SUBJECT: JAMES A. FITZPATRICK NUCLEAR POWER PLANT – RELIEF REQUESTS
I5R-02, I5R-03, AND I5R-04 FOR ALTERNATIVES TO CERTAIN ASME CODE
REQUIREMENTS (CAC NOS. MG0116, MG0117, AND MG0118; EPID
L-2017-LLR-0083, EPID L-2017-LLR-0084, AND EPID L-2017-LLR-0085)

SAFETY EVALUATION BY THE OFFICE OF NUCLEAR REACTOR REGULATION

SAFETY EVALUATION BY THE OFFICE OF NUCLEAR REACTOR REGULATION
RELIEF REQUEST I5R-03, REVISION 0, TO USE ENCODED PHASED ARRAY ULTRASONIC
EXAMINATION TECHNIQUES IN LIEU OF RADIOGRAPHY EXAMINATION
EXELON GENERATION COMPANY, LLC
JAMES A. FITZPATRICK NUCLEAR POWER PLANT
DOCKET NO. 50-333

SAFETY EVALUATION BY THE OFFICE OF NUCLEAR REACTOR REGULATION
RELIEF REQUEST I5R-04, REVISION 0, TO PERFORM INSERVICE ULTRASONIC
EXAMINATIONS OF REACTOR PRESSURE VESSEL THREADS IN FLANGE EXAMINATION

Figure 1. Schematics of the RPV Flange Stud Hole

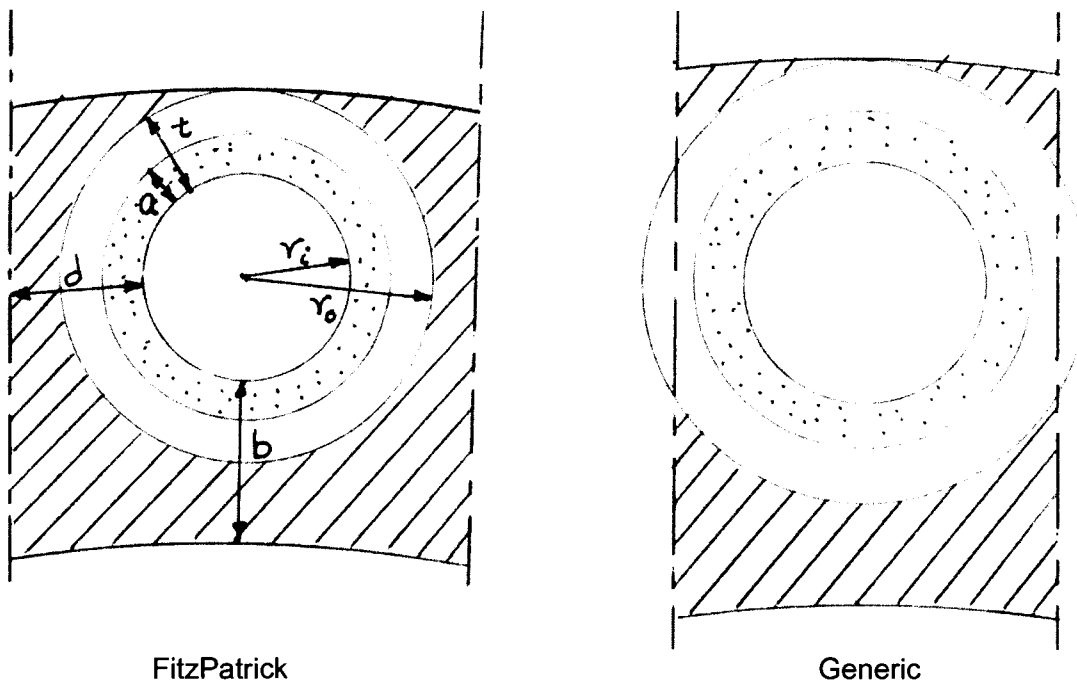
In Table 1 of its submittal for Relief Request I5R-04, the RPV flange thickness at the stud hole for FitzPatrick is 13.5 inches versus 16 inches for the generic stress analysis and is not bounded by the generic analysis. This feature is common to all boiling-water reactors (BWRs). However, due to an oversight, the unboundedness was not evaluated in the June 26, 2017, safety evaluation for the relief request for the 19 units, which included many BWRs. The NRC staff has evaluated the significance of this seemingly unbounded parameter in this relief request. This safety evaluation should be referenced in future applications for BWRs. The FitzPatrick RPV has 52 studs around the circumference with an inner RPV radius of 109.4 inches versus 54 studs and 86.5 inches for the generic analysis. This makes FitzPatrick's circumferential thickness between stud holes approximately twice that of the generic analysis. Therefore, for the same preload, FitzPatrick's axial stresses in the material between the stud holes will be much less than the generic analysis and are, therefore, bounded by it. For comparison, the NRC staff provides schematics of the generic stress model and the FitzPatrick model in Figure 1 below with key dimensions (approximate values) listed in Table 1. The above observation is different in the RPV radial direction where the total flange radial thickness (considering both sides of the stud hole) is 7.5 inches for FitzPatrick versus 9 inches for the generic analysis. Since the preload contributes the most to the maximum K (85 percent to 96 percent according to Figure 6-1 of the EPRI report), examining the stress plot for the preload case in Figure 6-5 of the EPRI report is sufficient. Figure 6-5 shows that at the assumed crack location (i.e., ~ 15 percent down from the top edge of the figure), the axial stress is high in areas adjacent to the stud hole, but decreases rapidly to low and then negative values toward the RPV flange outer edge. This means that the stress pattern of the generic analysis is not sensitive to the reduced thickness between the stud hole and the outer edge of the FitzPatrick RPV flange. This observation applies to the reduced thickness between the stud hole and the inner edge of the FitzPatrick RPV flange, but of a much less concern because a significant portion of the thickness is under compressive stresses.

Key Dimensions	Relevant to Stress Model				Relevant to Fracture Model	
	r_i (inches)	t (inches)	B (inches)	d (inches)	r_o (inches)	a (inches)
Generic	3.5	3.06	5.94	2.08	6.56	1.53
FitzPatrick	3	2.55	4.95	4.09	5.55	1.275

The NRC staff examined the generic RPV flange model schematics (Figures 6-2 and 6-8 of the EPRI report) and the FitzPatrick geometry features discussed in Section 4.2 above and determined that a thick-cylinder model (with r_i and r_o shown in Figure 1) with an inner circumferential crack of a uniform depth ("a" shown in Figure 1) under uniform axial stresses can be used to estimate the adjustment factor for the maximum applied K at the crack tip close to the RPV flange outer edge for FitzPatrick. This adjustment factor is needed to account for the geometric differences between the FitzPatrick model and the generic model. This estimation is conservative because, as indicated in Figure 1, much more flange material close to the RPV flange outer edge outside the imaginary thick-cylinder is not considered in the FitzPatrick thick-cylinder model than in the generic thick-cylinder model. The applied K for the simplified thick-cylinder model and the key geometric parameters are summarized in the following table for both the generic and FitzPatrick cases.

A lower preload stress and a geometry adjustment factor of 0.91 for the applied K for FitzPatrick means that the applied K for FitzPatrick is bounded by the generic flaw evaluation, even though the thickness between the stud hole and the RPV flange outer edge for FitzPatrick is smaller than the generic model.
